Enquiries to	Zara Rogers	My reference	059275
Direct Line	N/A	Your reference	APP/25/00639
Date	4 March 2026	Email	havantdc@hants.gov.uk

Re: APP/25/00639 At Proposed Development site (former Electricity Board site), Bartons Road, Havant

Erection of 90 dwellings with associated landscaping, parking and improved access

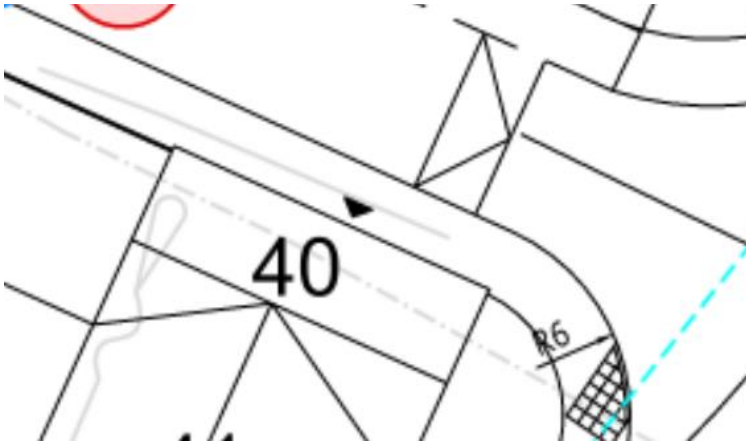
Upon review of the internal site layout plan, whilst a shared use path has been provided along the main spine road, a visitor space on the opposite side of the road to plot 8, slightly overhangs (top left of the space) the shared use path, which is not acceptable. Furthermore, there are several other visitor bays that are missing a hardstanding area for accessing the vehicle, and therefore a hardstanding to the rear of the visitor spaces should be provided. Additional crossing points where appropriate should also be provided in the vicinity of the visitor bays to allow pedestrians to safely cross.

The block plan shows that for several plot numbers the building line encroaches on the 2.0m footway width (for reference plot 40 is shown below but this is also present in other areas). If this is the roof line of the proposed dwelling the building lines should also be shown for clarity. The Highway Authority request that this is reviewed to ensure a minimum footway widths can be achieved throughout the site.
